Mr. Herb Norwegian Chairman Deh Cho Land Use Planning Committee Box 199, Fort Providence NWT X0E 0L0

#### Re: Response to November 2005 Draft of Dehcho Land Use Plan

#### **CAPP Detailed Comments**

# **Impact on Activities of Linear Disturbance Thresholds**

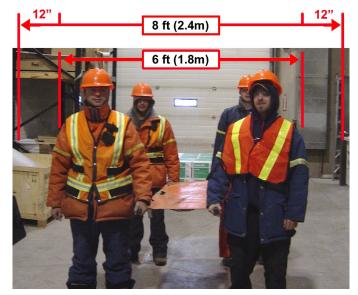
CAPP is suggesting that the 1.5m definition for linear disturbance be re-examined as it poses a significant operational challenge to conduct seismic operations under that width of line.
